SUBJECT: LONGERON CHAFING

AIRCRAFT MODEL: Husky Model A-1, A-1A, A-1B, A-1C-180, A-1C-200
(CERTIFIED IN ANY AIRWORTHINESS CATEGORY)

Service Bulletin No. 31

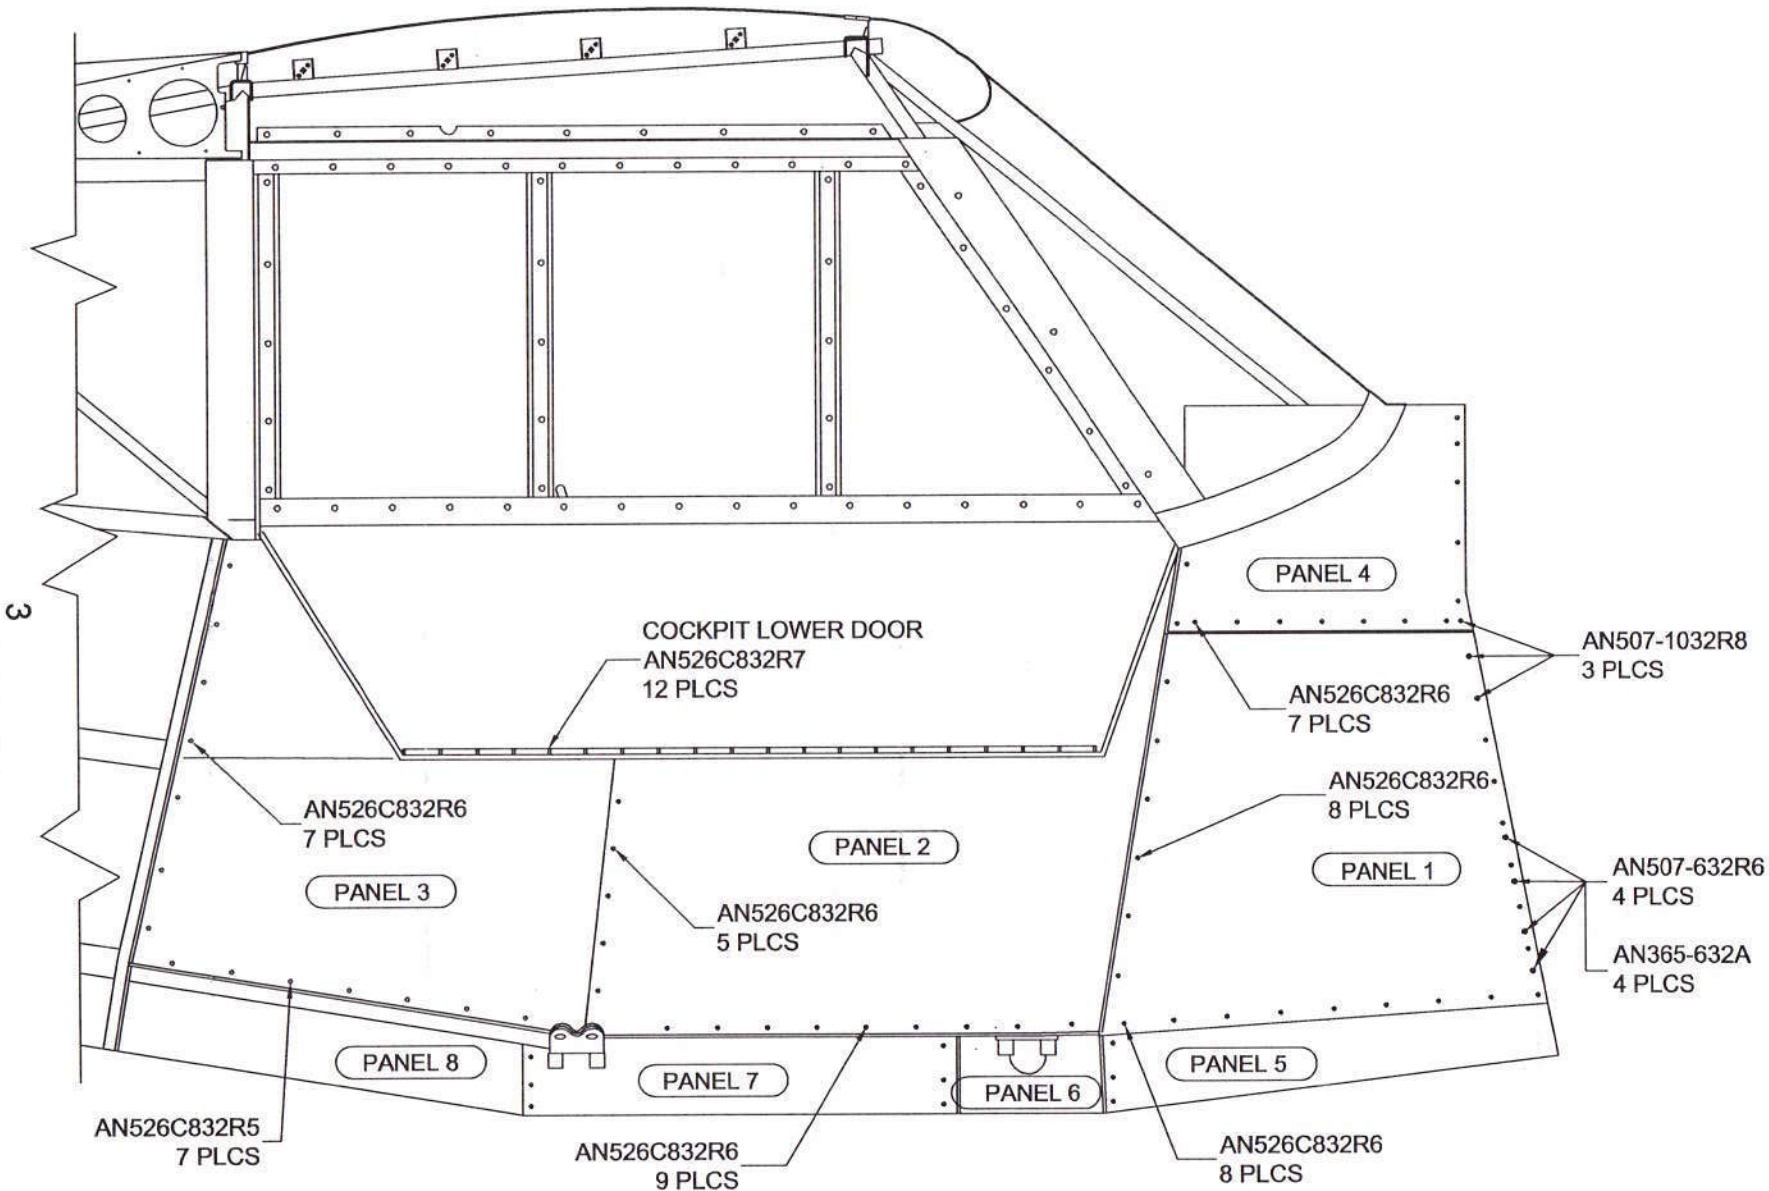
Step 6, If Nylon washers are installed on the removed screws, they can be reused on the screws provided in the screw kit only when installed as described below. Install the RH side panels in reverse order as described above and the illustration views on page 3 but leave out the bottom row of screws on panels 2 & 3, connecting to panels 6, 7, & 8. At this time install AN526C-832R5 screws without nylon washers to connect panels 3 and 8. Install AN526C-832R6 screws without nylon washers to connect panel 2 to panel 7 with panel 6. Install the LH side panels in the reverse order as described above but leave out the bottom row of screws on panels 10 and 11 connecting to panels 13, 14, and 15. At this time install AN526C-832R5 screws without nylon washers to connect panels 11 and 15. Install AN526C-832R6 screws without nylon washers to connect panel 10 to panel 14 with panel 13.
